No. 86-3

MCM 185/205 Wiring Harness Routing S/N A608353 and Below:

Figure 1.

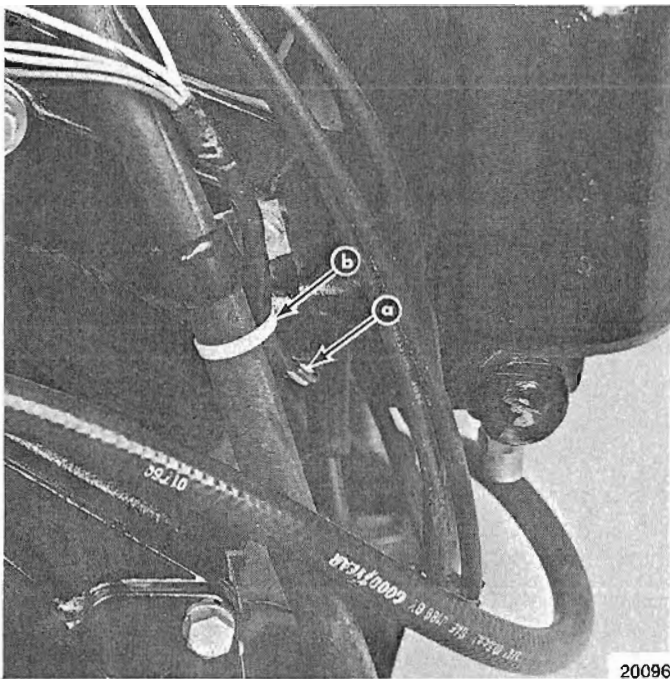
Some reports have been received from the field of the wiring harness chafing and/or melting in the exhaust manifold area on the rear starboard side of the engine as shown, (A) in Figure 1.

1. Remove sta-strap, (B) Figure 1.
2. Loosen coil mounting clamp and relocate coil so primary studs are straight fore and aft as shown in Figure 2. Tighten clamp.
